REPORT TO COUNCIL

Application: DP17-0154 & DVP17-0157

Address: 1187 Sunset Drive

Subject: Rezoning Application

South Tower

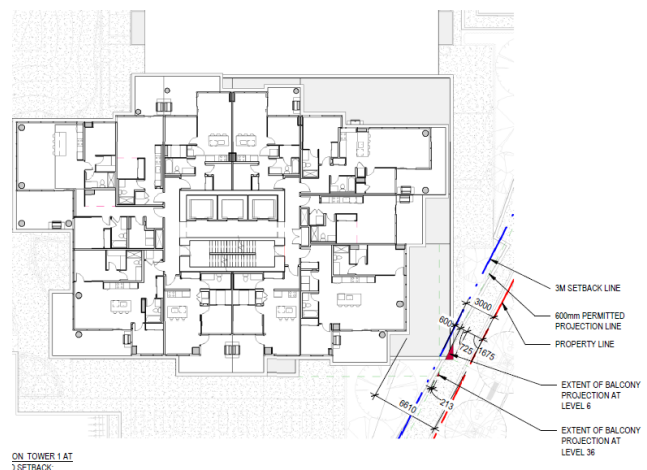
Lastly, the variance to increase the maximum balcony projections is minor according to Staff. The applicant originally had a building setback variance to the property line but after a redesign to eliminate that variance there remained a balcony projection variance. Due to the angle of the towers the area of balcony intruding beyond the maximum projection is very small (see red areas in images below).

To vary the permitted balcony projection into the side yard (Sunset Drive) from 0.6m to 1.59m at various levels as described in Schedule 'A' and to vary the permitted balcony projection into the front yard (Water Street) from 0.6m to 1.32m on level 6 & 0.87m on level 36 as described in Schedule 'A'.
